SHOP DRAWING REVIEW

VT Route 73 - Bridge 13 (Project # ER STP 0162 (19)) Rochester, VT

28'x10' Archcon w/ Wingwalls and Footings - Layout Views

Comment #	Shop Dwg Detail/Sheet	VHB Comment	Michie Response
1	1/S1	Verify with contract documents	Revised. Lane size is 14'
2	2/S1	These should match?	No. The dimension in 1/S1 is along slope. The dimension in 2/S1 is a plan dimension.
3	2/S1 & 3/S2	Does not match contract plans	The slope @ T.O. subfooting must be the same on both left abutment and right abutment in order for precast height to remain constant. We held inlet elevations and modified outlet elevation on east abutment. On west abutment (pedestal side): 1480.94 - 1475.26 = 5.68. Modify east abutment (slab side): 1486.19 - 5.68 = 1480.51.
4	2/S1	Not typically what we do	We assume the request here was for all voids to be filled with nonshrink grout. Shops have been modifed accordingly.
5	2/S2	Is grade accurately drawn on both sides?....	Grade was not accurately drawn. Shops have been modified to more accurately reflect the intent on the shop drawings. That said, they are still drawn "approximately" and are not intended to replace the requirements of the contract documents. Ques

1 S2.0 FOOTING LAYOUT PLAN VIEW
⅛" = 1'-0"

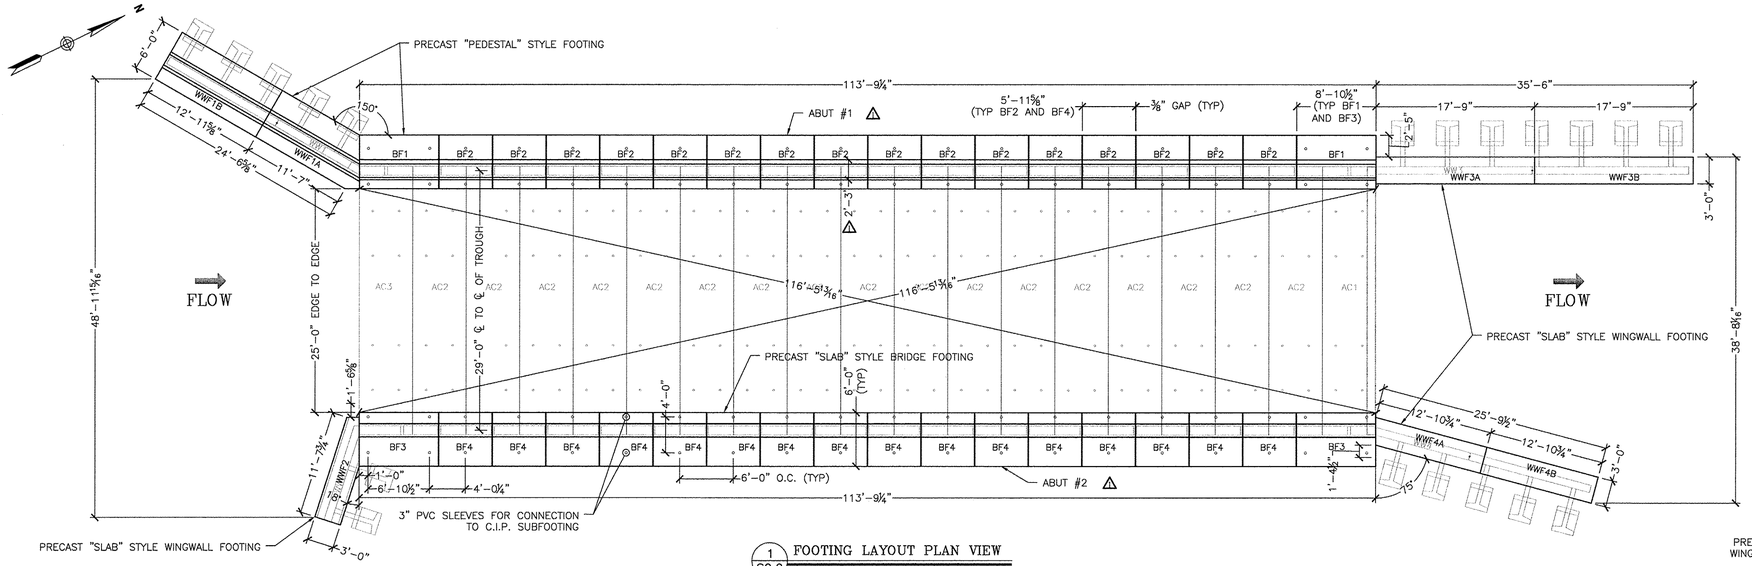
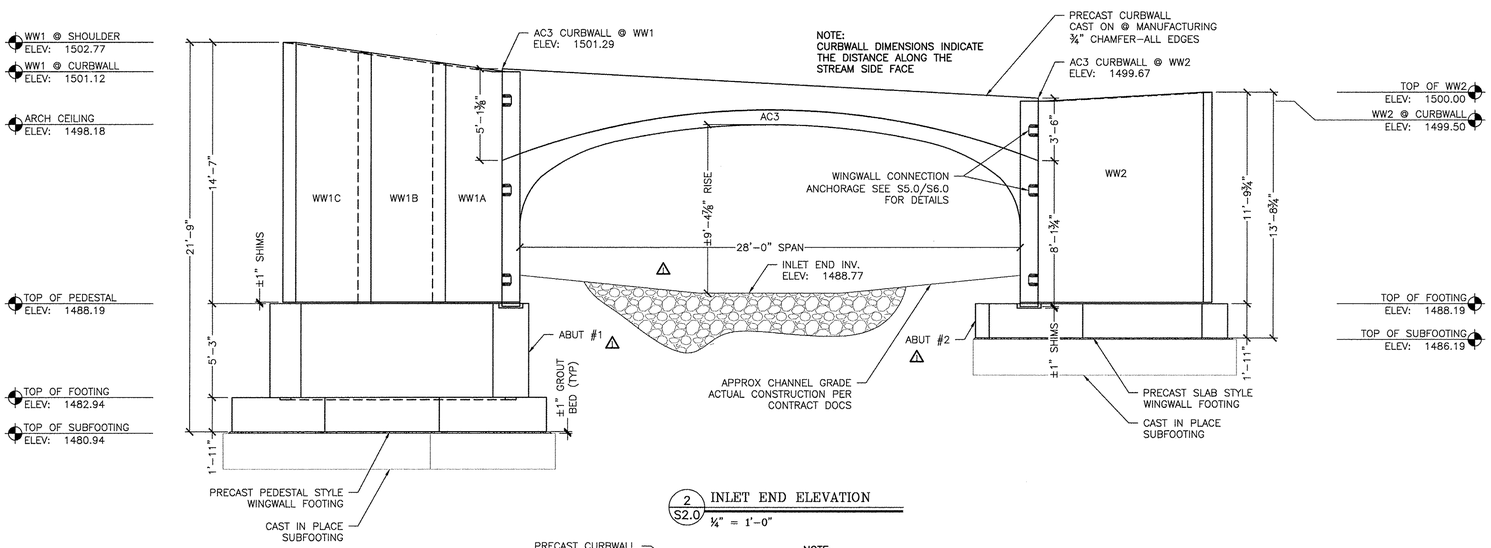
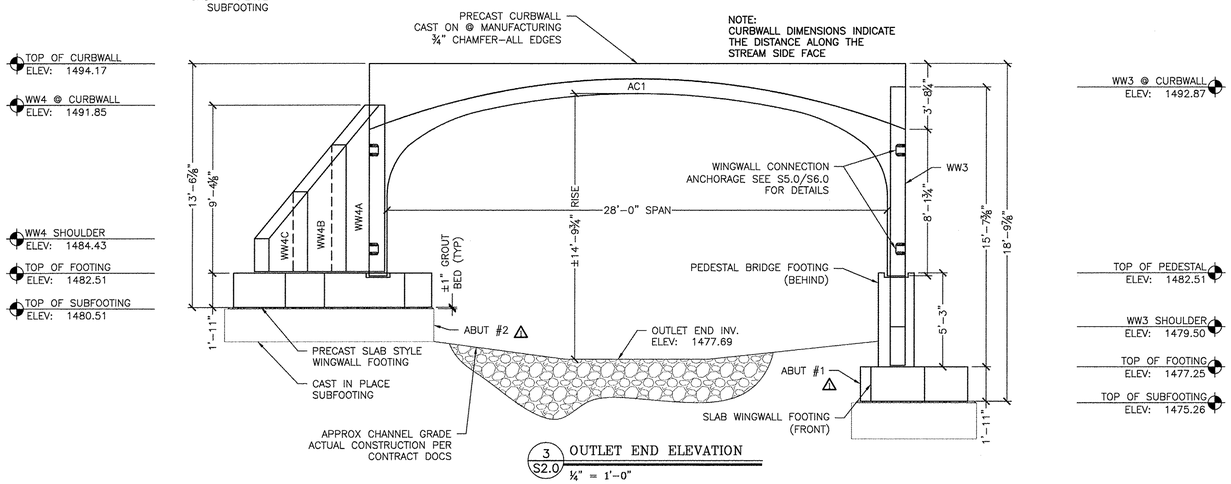
11	2/S8	will subfooting be 1:1?...etc	Details shown regarding subgrade preparation of wingwalls have been simplified to avoid conflicts with the requirements of the contract documents
12	S2	--	Footing layout and End elevations now identify abut 1 and abut 2 as shown in the contract plans
13	2/S6	--	bridge plaque is now shown on WW1A

7 S3.0 BF2 PLAN VIEW
½" = 1'-0"

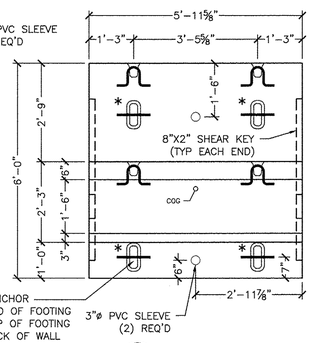
6	7/S2	Show where this will be located in other views	The weephole location is detailed with each individual precast component
7	4/S3, 7/S3, 3/S4, 7/S4, 7/S5, 1/S8	structures has been requiring a minimum of 2" clr for reinforcing	Per discussion on 5/13/14 with Scott Burbank @ VHB, 3" clear will be provided on footings, 2" clear will be provided on wings and curbs, and for the arch: 2" clear on outside face and 1 1/2" clr on inside face. Designs and shop details have be revised accordingly
8	4/S6	might want to check with structures about use of weepholes	Per discussion on 5/13/14 with Scott Burbank @ VHB, no weepholes will be allowed on the arch. Weepholes will be used in the wingwalls only.
9	1/S4, 2/S4, 1/S8	why are these narrower than the others?....	The wingwall footings should not have any trough at all. This has been removed from details 1/s4, 2/s4, and 3/s4.
10	S6	labeling wingwall elevations would be helpful	wingwall elevations @ bridge and @ tip are provided on details 2/s2 and 3/s2. Additional intermittent elevations have been added for clarity in details 2/s6, 4/s6, 6/s6, 2/s7, 4/s7, and 6/s7.
